Forsyth County Procurement

ADDENDUM #6

RFP 20-78-1620

For: Providing all labor, equipment and materials for the construction of a new Juvenile Justice Center at 875 Lanier 400 Parkway, Cumming, GA 30040. Project includes a multi-phased site development, demolition of existing motel structures and construction of new 62,000 square foot Juvenile Court building.

5 SECTION DETAIL
SCALE: 1 1/2" = 1'-0"

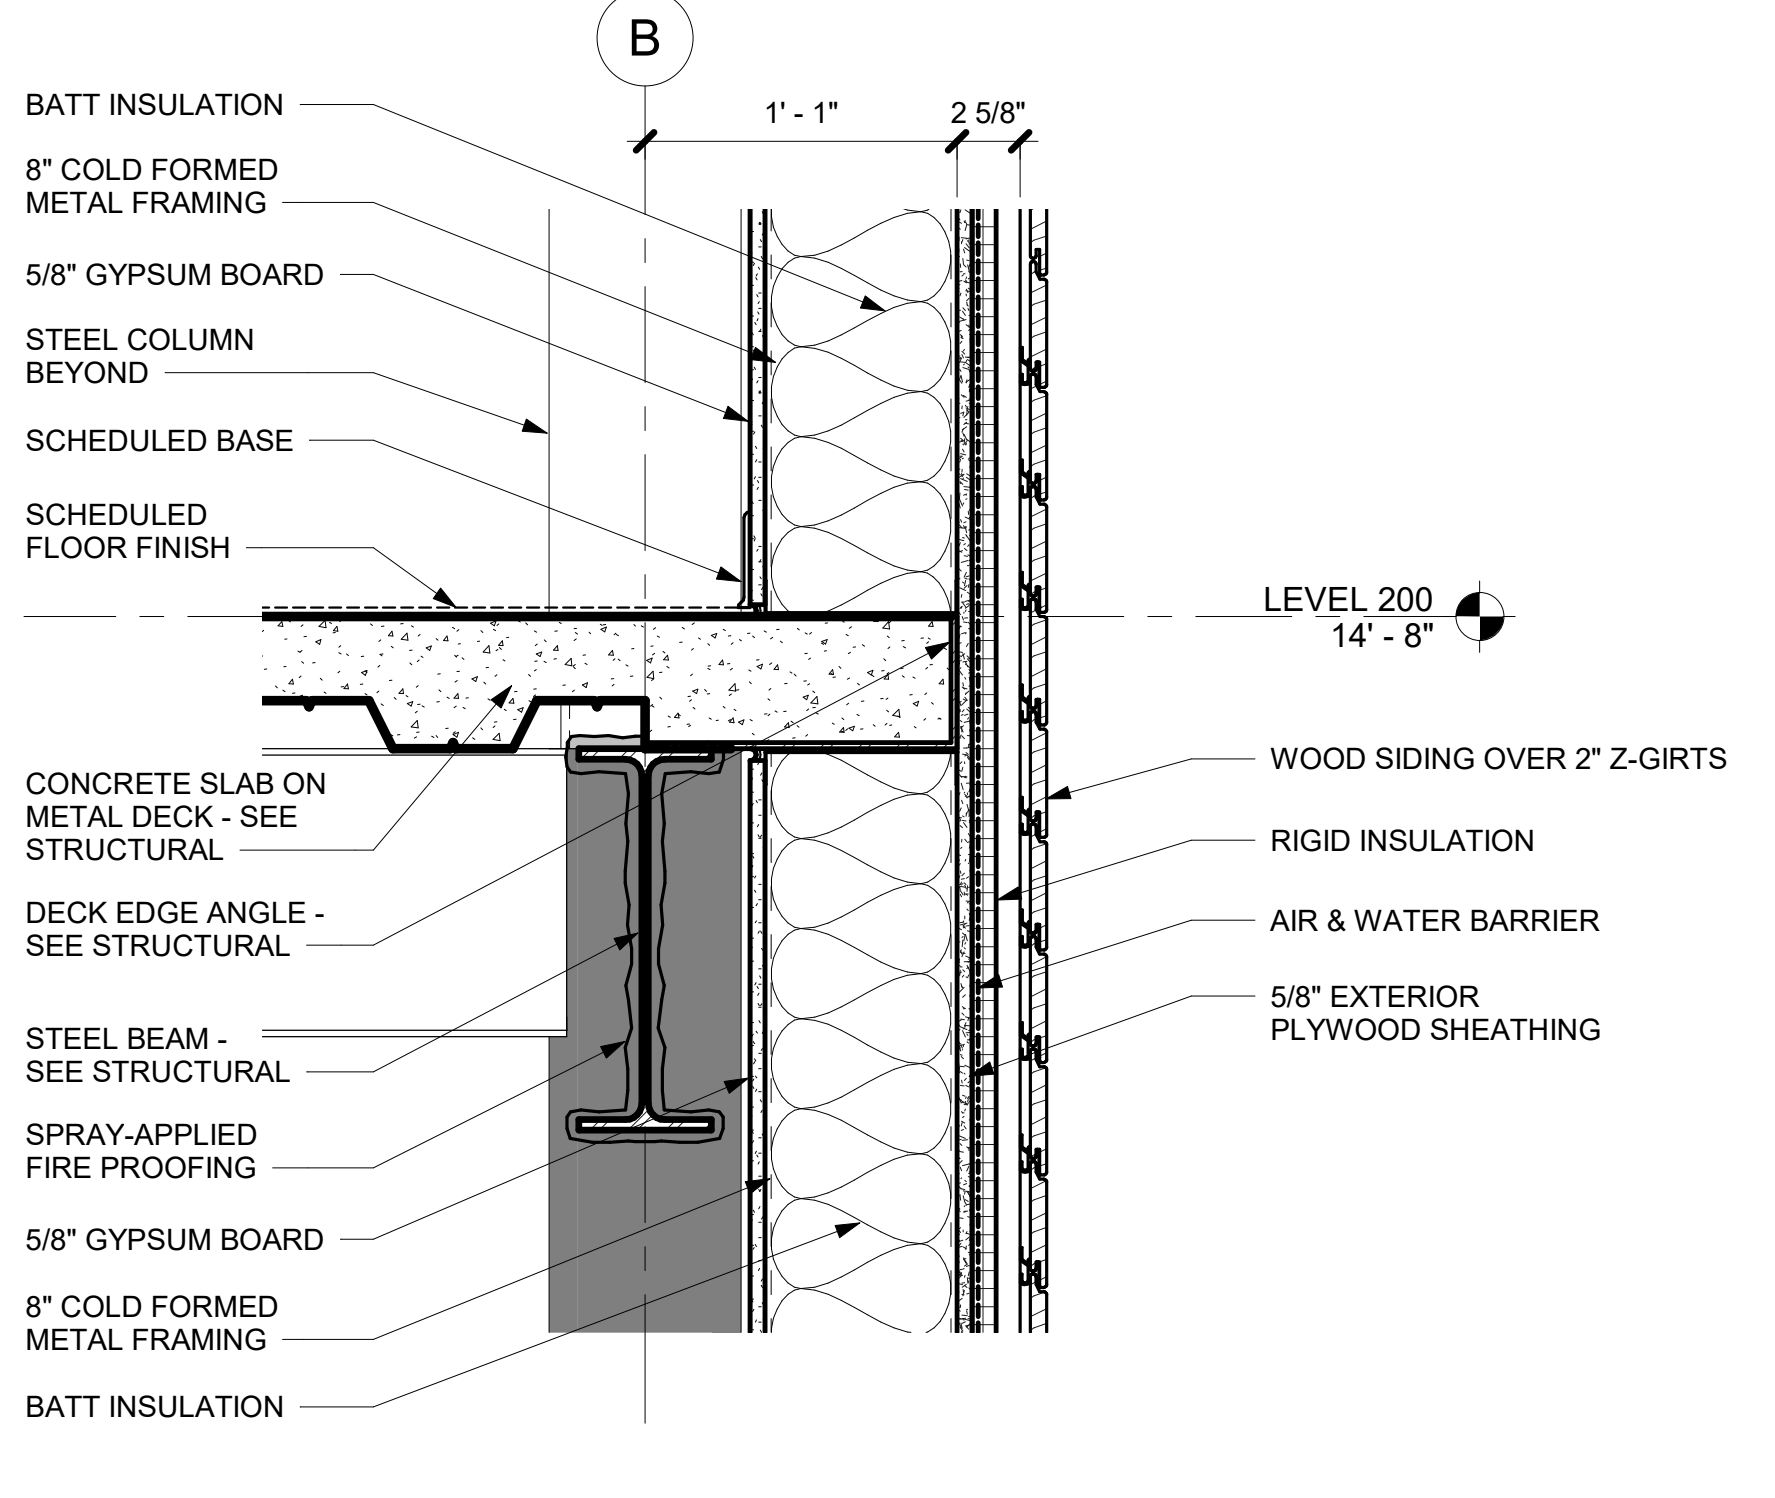
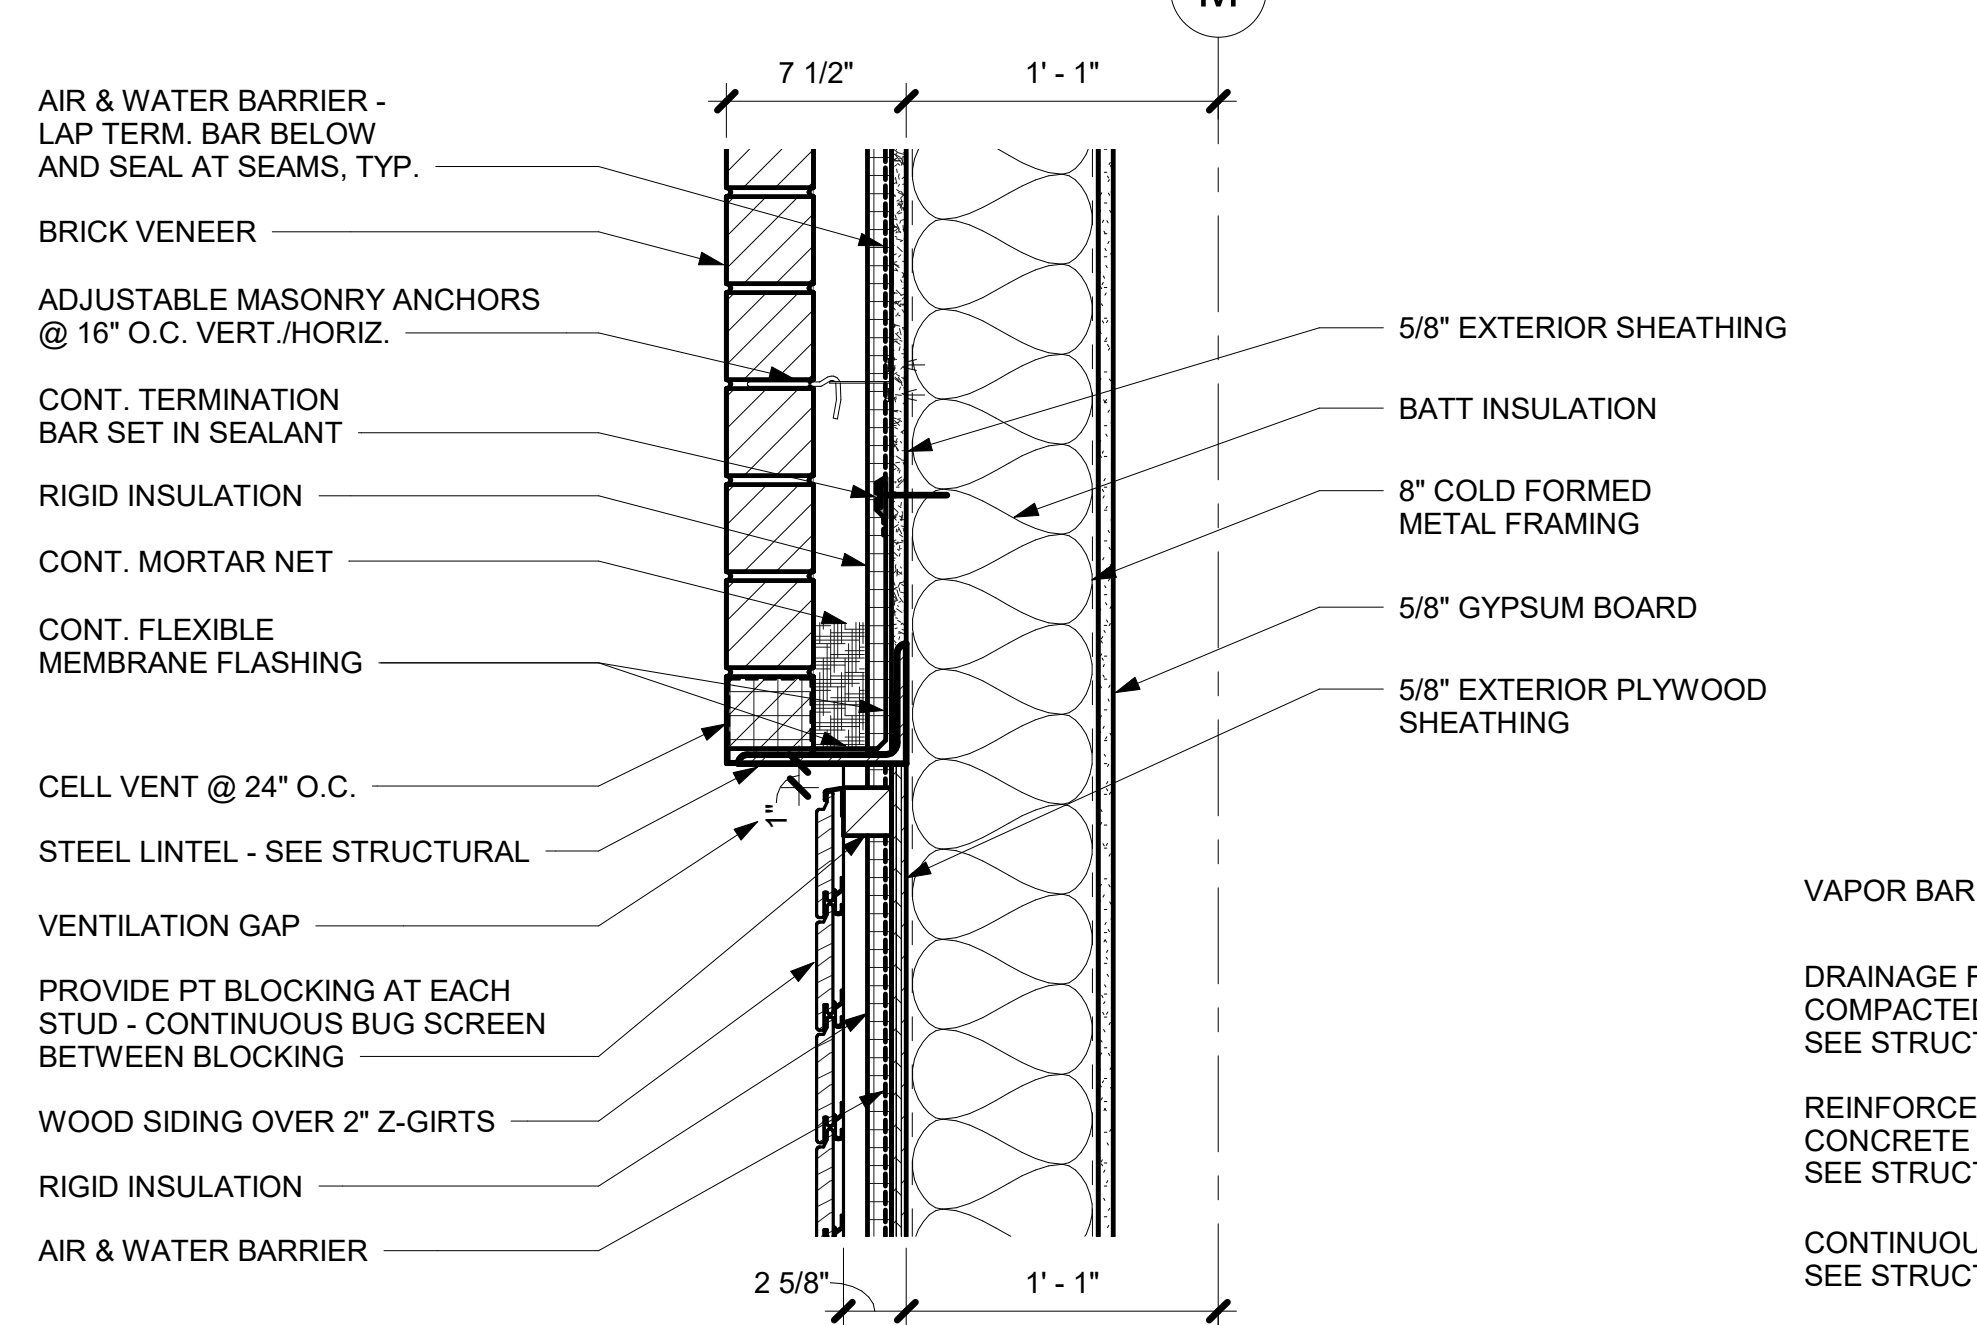
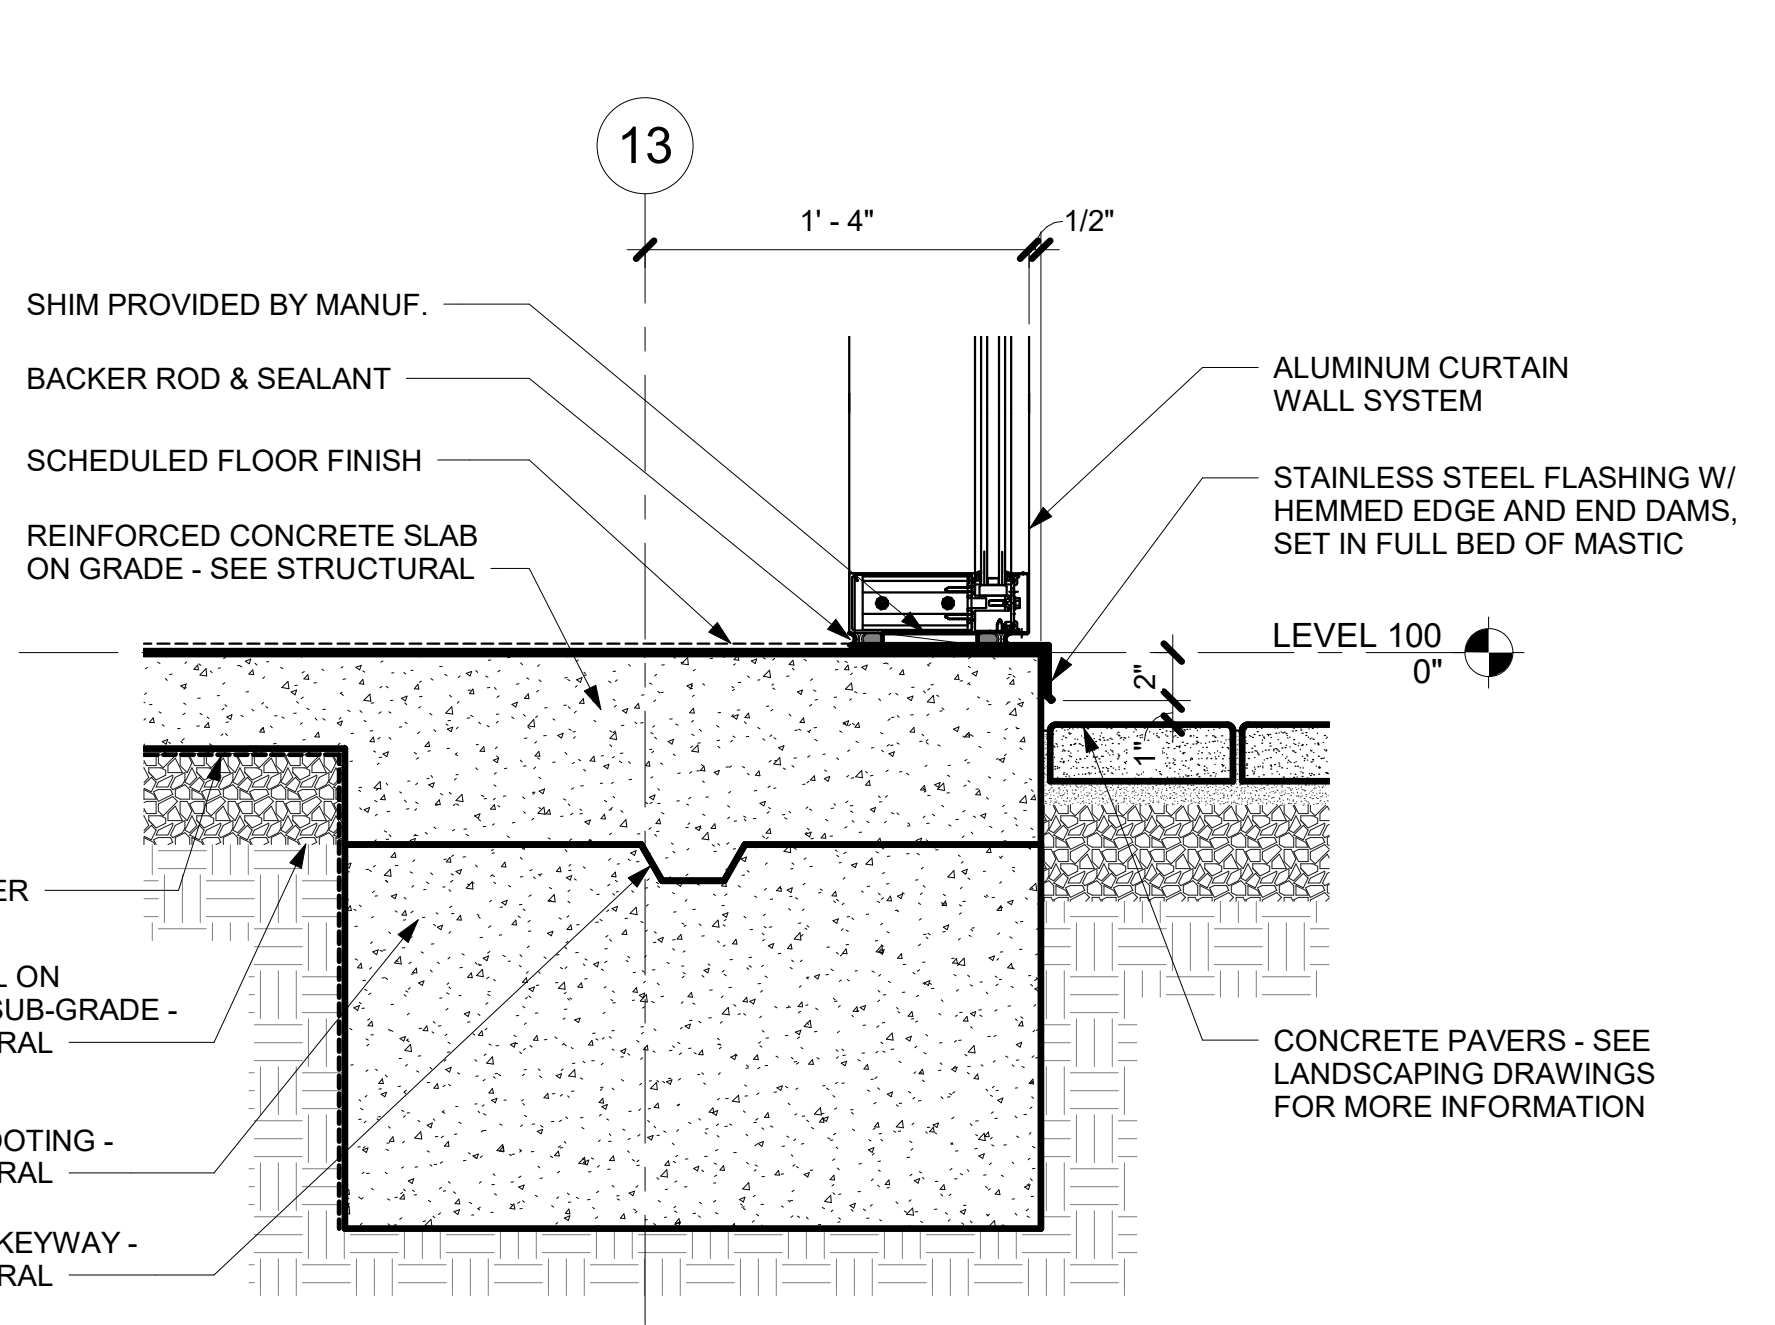
71. Detail 9/A-5.73, window sill note says, “see interiors”. There is no window sill information on interior drawings, please clarify what material window sills are made of.

1. Removed references to “SEE INTERIORS” on window sill details.
 2. Reference sheet A-5.73 SECTION DETAILS revised under addendum #06 dated 07/16/2020.

12 SECTION @ RAILING
SCALE: 1 1/2" = 1'-0"

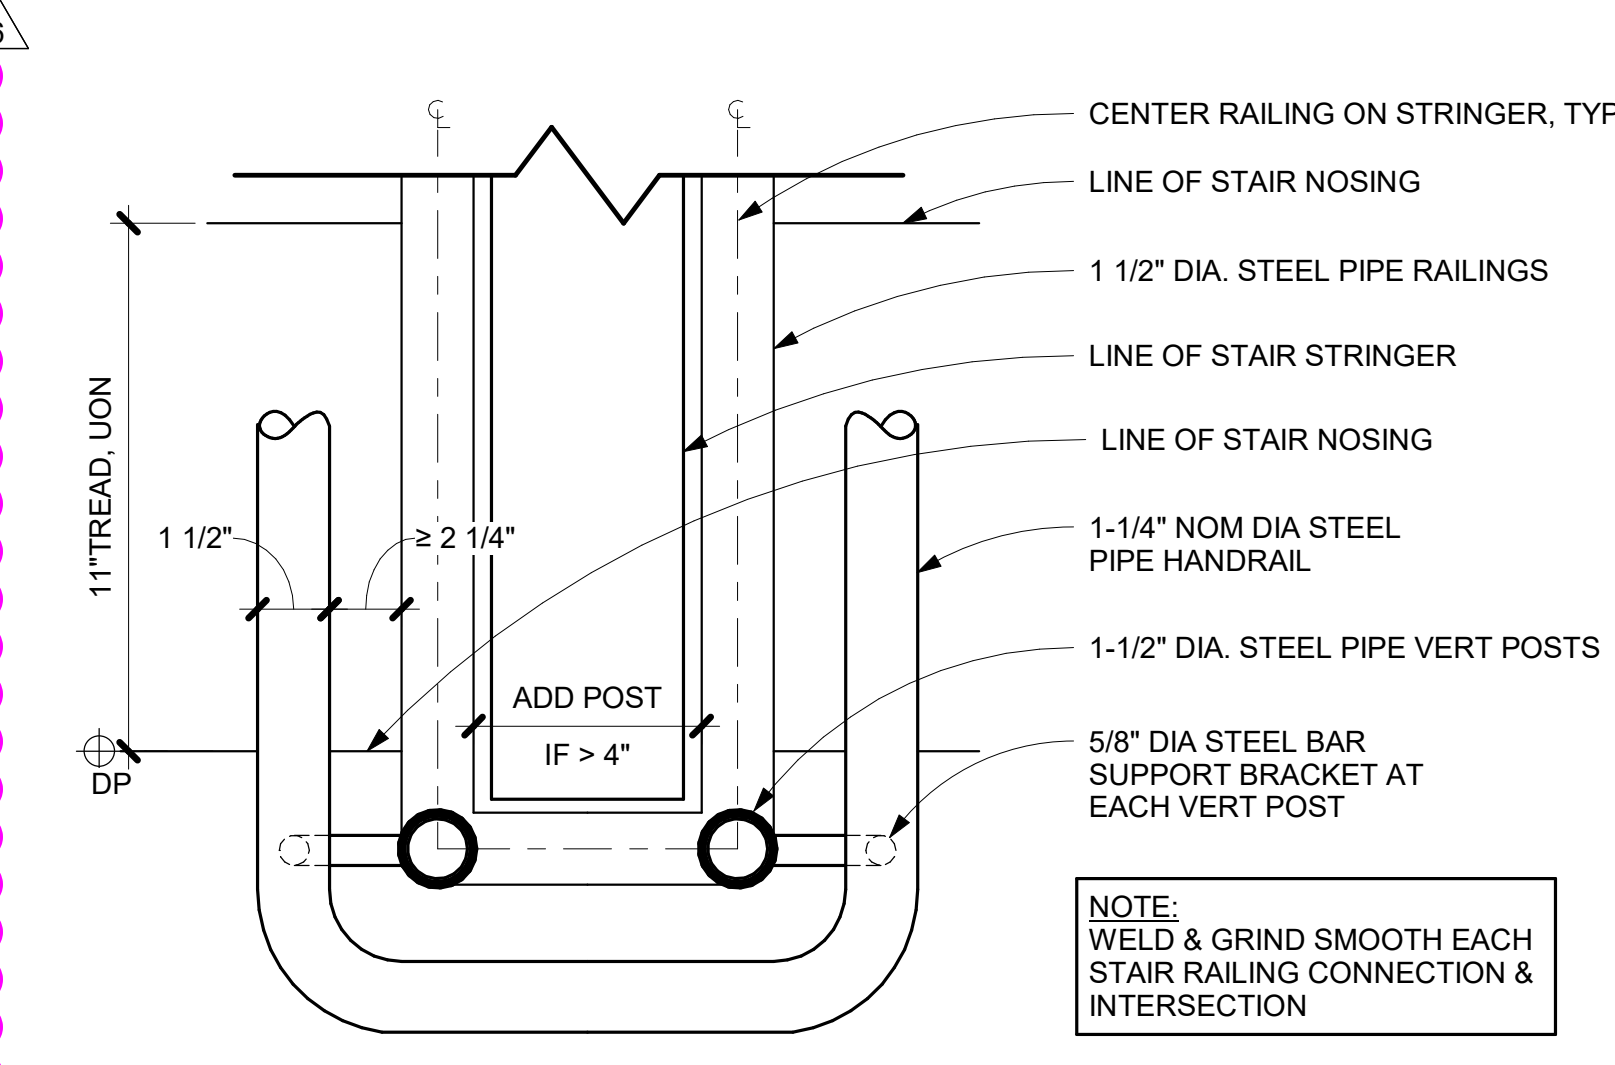
- 2-9 Sheet A-6.52 STAIR SECTIONS AND DETAILS:
1. Added detail 12/A-6.52
 2. Reference sheet A-6.52 STAIR SECTIONS AND DETAILS revised under addendum #06 dated 07/16/2020.
